CLIVE PLANNING & ZONING COMMISSION

RE: Site Plan Amendment - 1229 NW 86th St - Discount Tire

Re: 1229 NW 86TH ST - Discount Tire Building Addition - Site Plan Amendment

TENANT IMPROVEMENT - EXPANSION

A.1

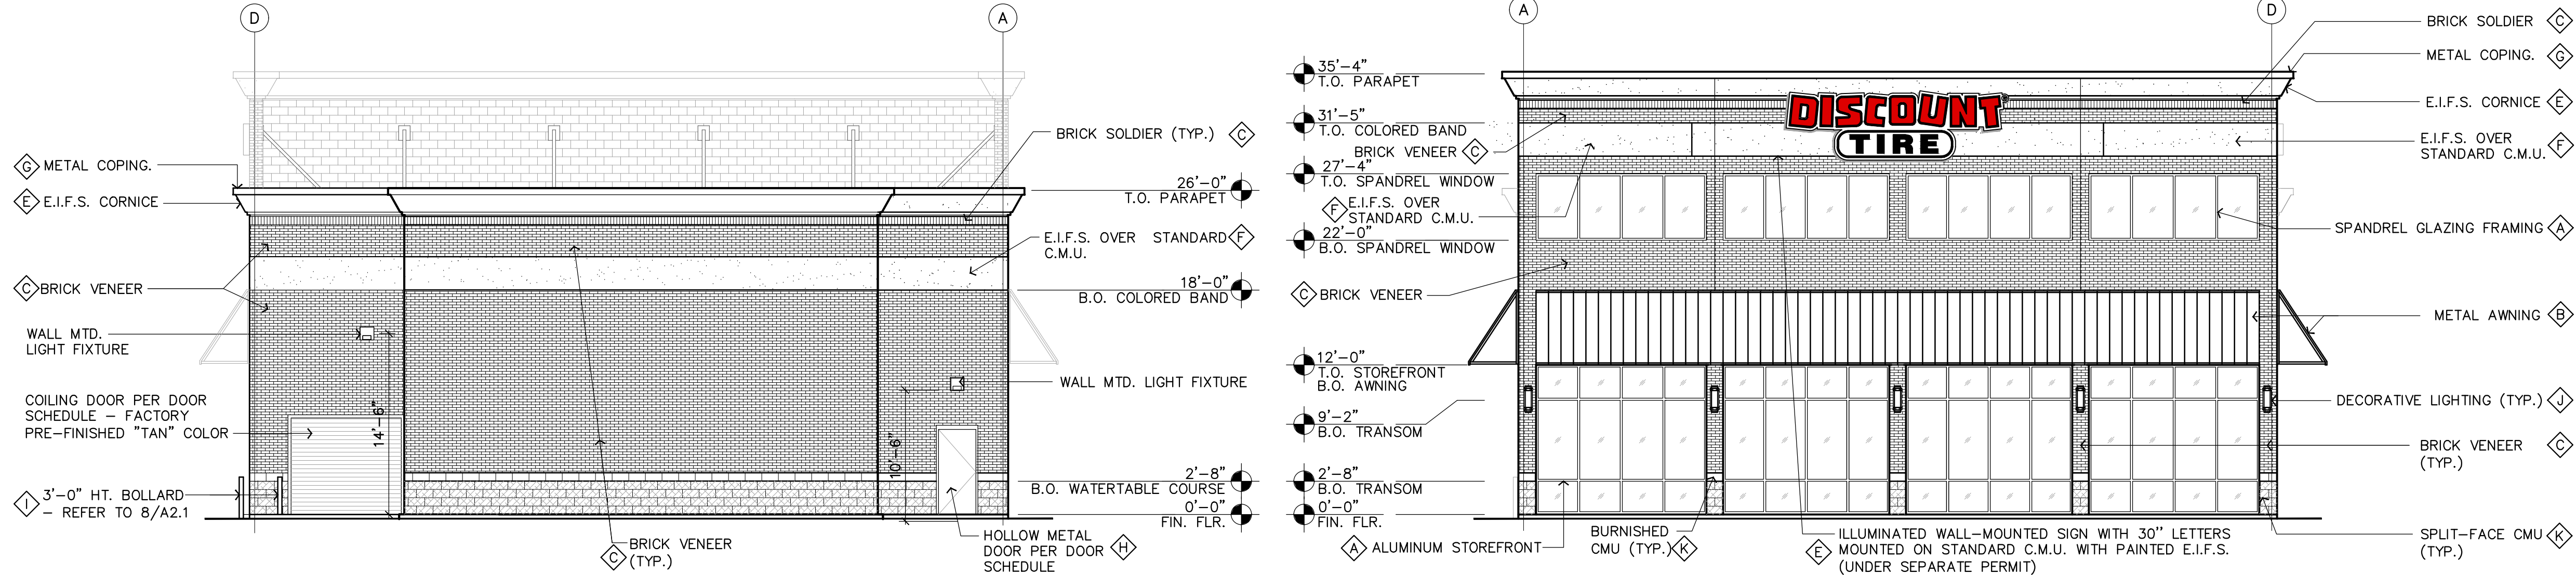
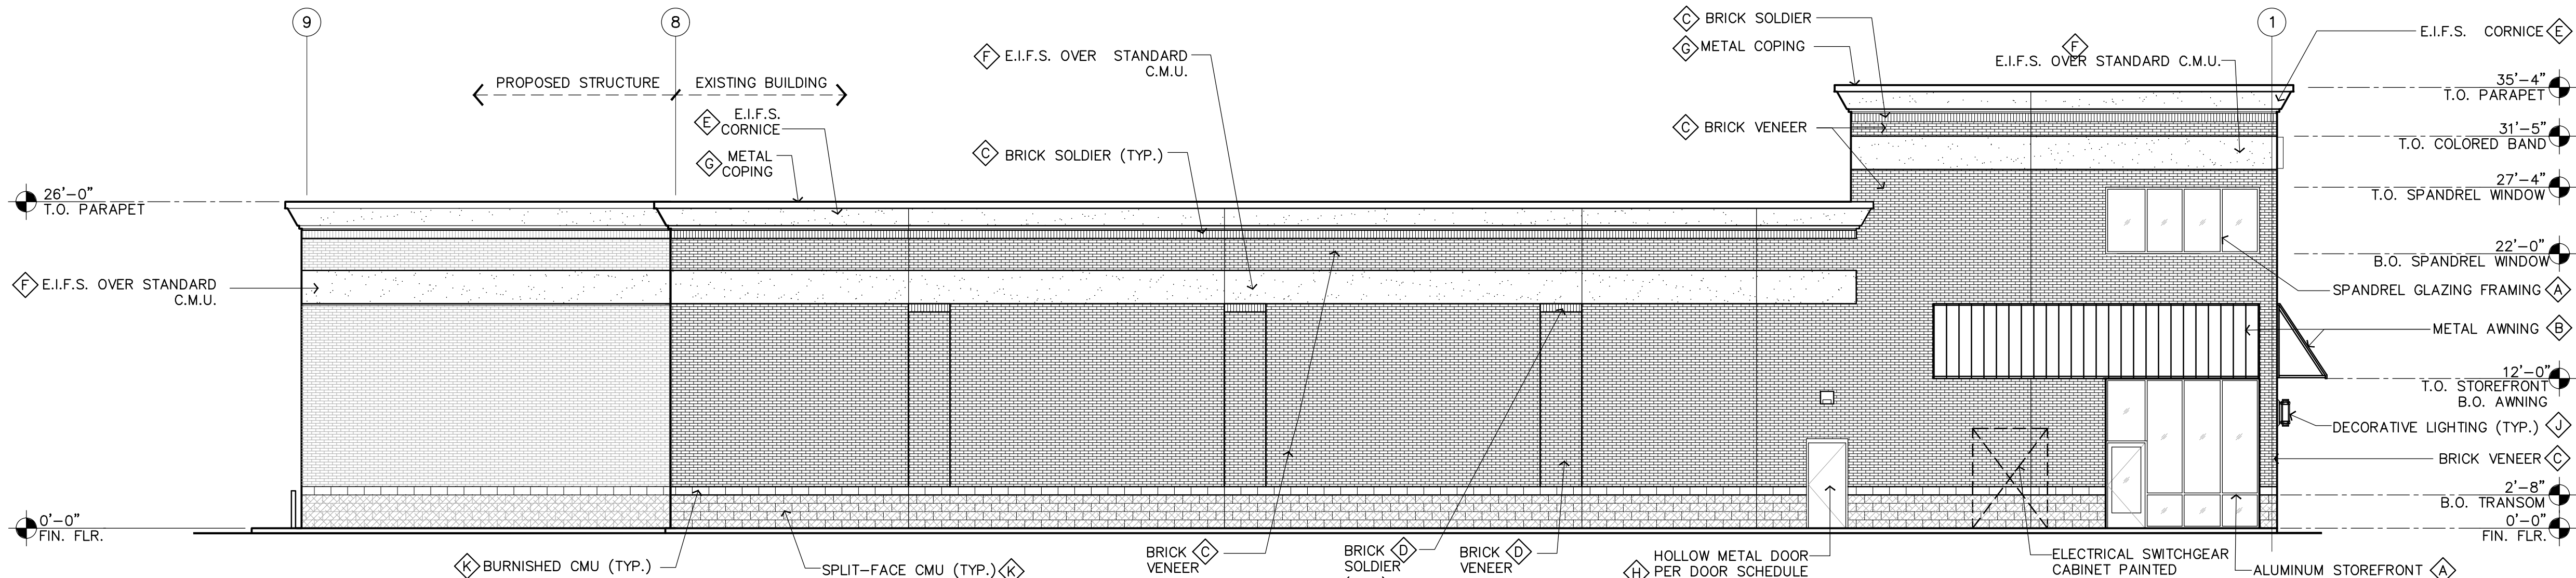
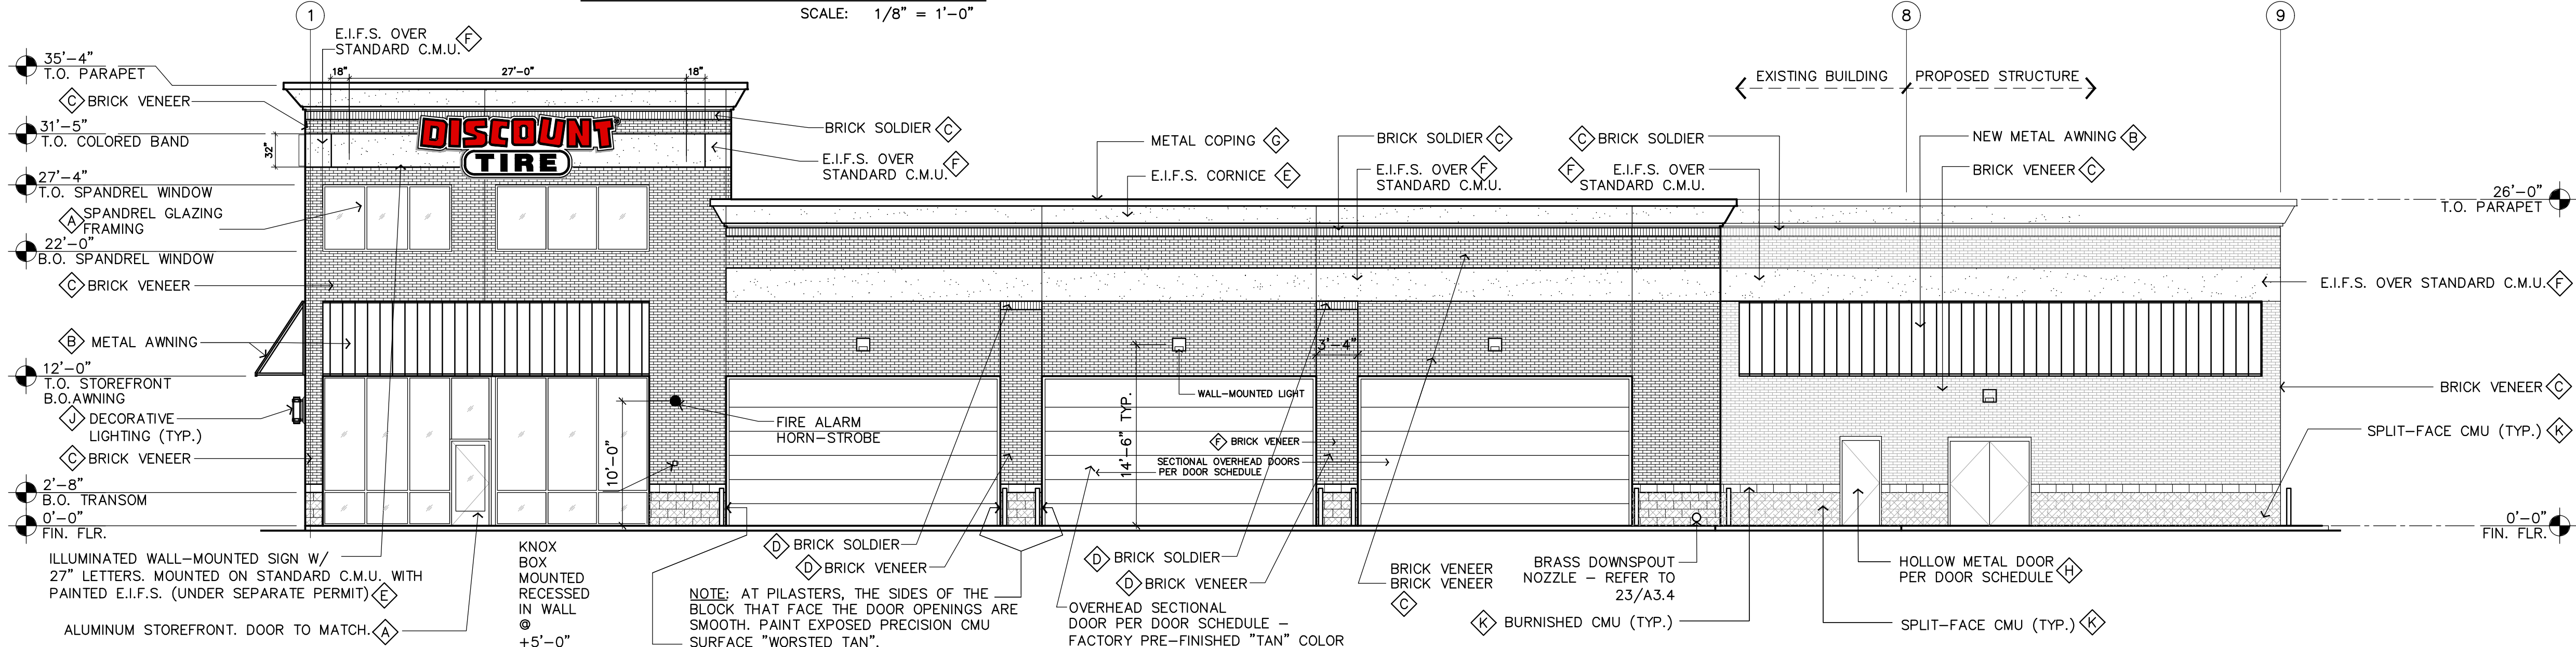
- **Architectural and Building Specifications:**
 1. Please include the Brick Veneer details- brand/manufacturer and color code- existing building a combination of Sioux City Brick in "Red Desert Range" and "Mission Pink Velour". Please ensure other colored materials are made to match the existing building : previous elevations included "SW oak barrel, burgundy, Antique White, Worsted Tan". This includes the new Trash Enclosure.
[THE FF. MATERIALS MENTIONED ABOVE HAVE ALL BEEN CALLED OUT ON SHEET A.2 - CONCEPTUAL ELEVATIONS.](#)
[CORRECTIONS DONE THRU COLOR/PAINT NOTES & GENERAL FINISH NOTES UPDATE.](#)

C000

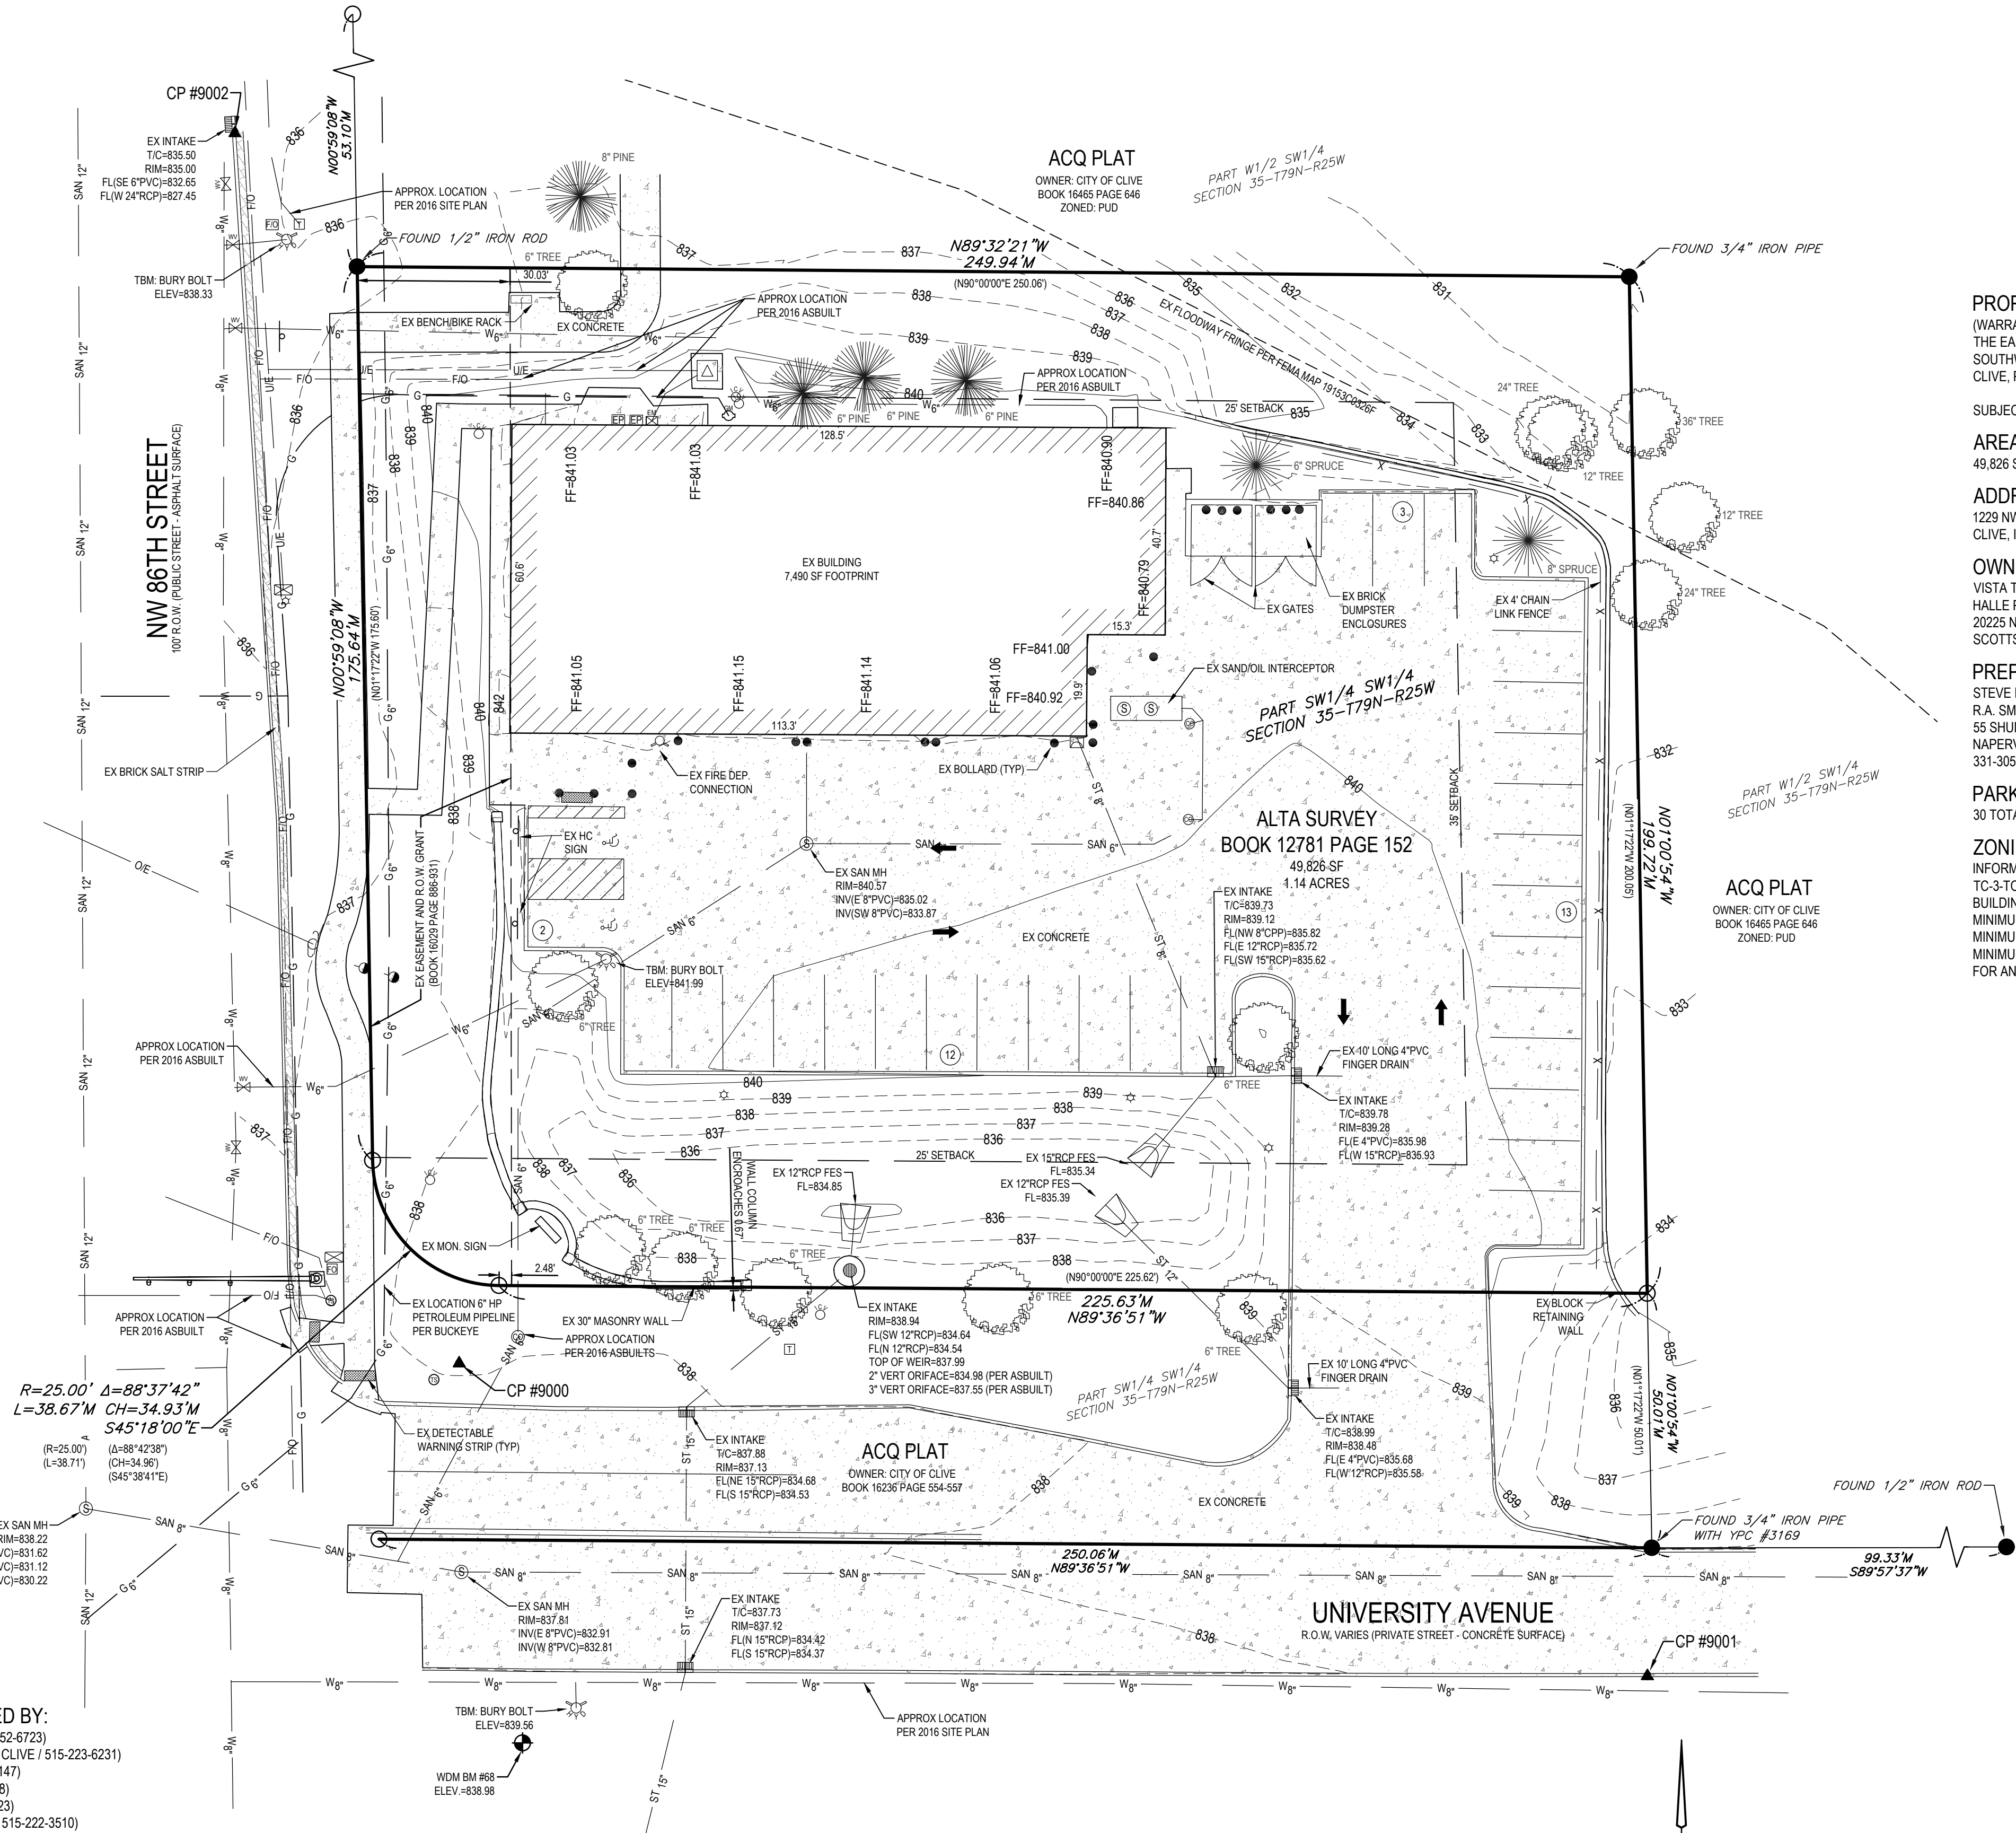
- **Cover Page:**
 1. Please add the Clive Site Plan and Construction Drawing Standard Notes to the plan set. Notes can be found in the Development Standards Manual Appendices at <https://cityofclive.com/developmentstandardsmanual>
[Notes added to C000](#)

2. Add the following note to the cover sheet: SUBJECT PROPERTY IS LOCATED IN UNSHADED ZONE 'AE' (AREAS DETERMINED TO BE WITHIN THE 1% ANNUAL CHANCE FLOODPLAIN) AS SHOWN ON THE FLOOD INSURANCE RATE MAPS FOR THE CITY OF CLIVE, POLK COUNTY, IOWA, MAP PANEL 19153C0326F WITH AN EFFECTIVE DATE OF 2-1-2019.
[Note added to C000](#)
